Design Concepts

Five design concepts were presented and reviewed at the Community Meeting on December 12, 2013.

Concept E

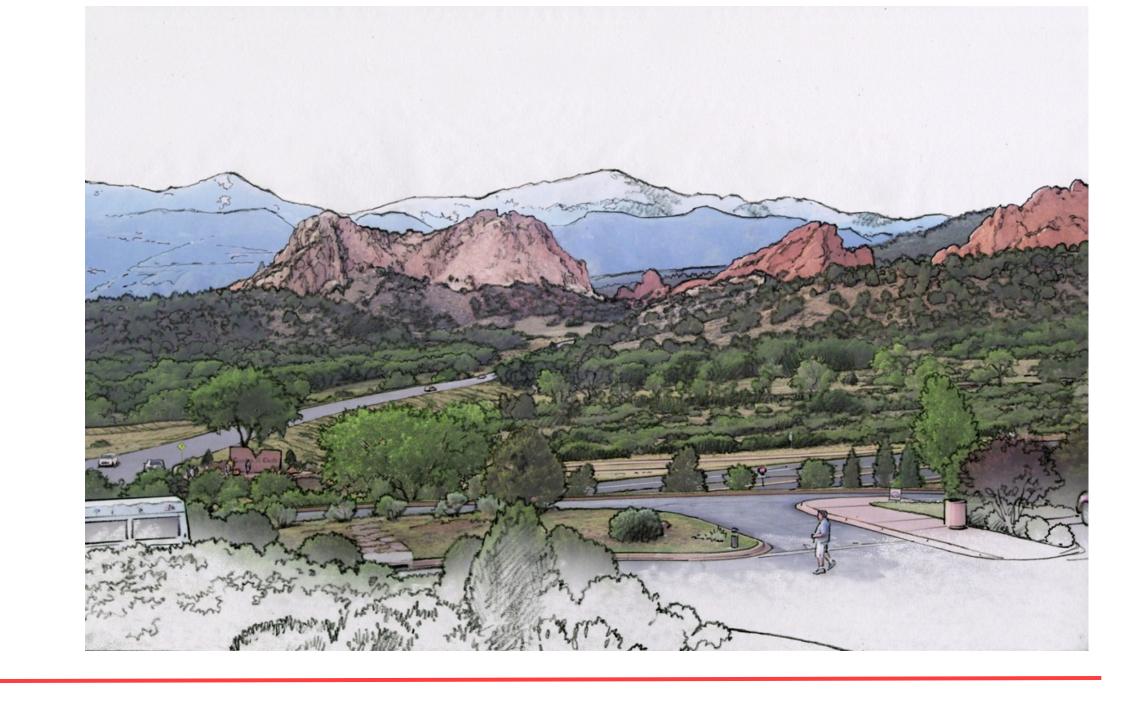
Primary community concerns:

- Sediment/debris build-up and maintenance
- Detention at Gateway Road
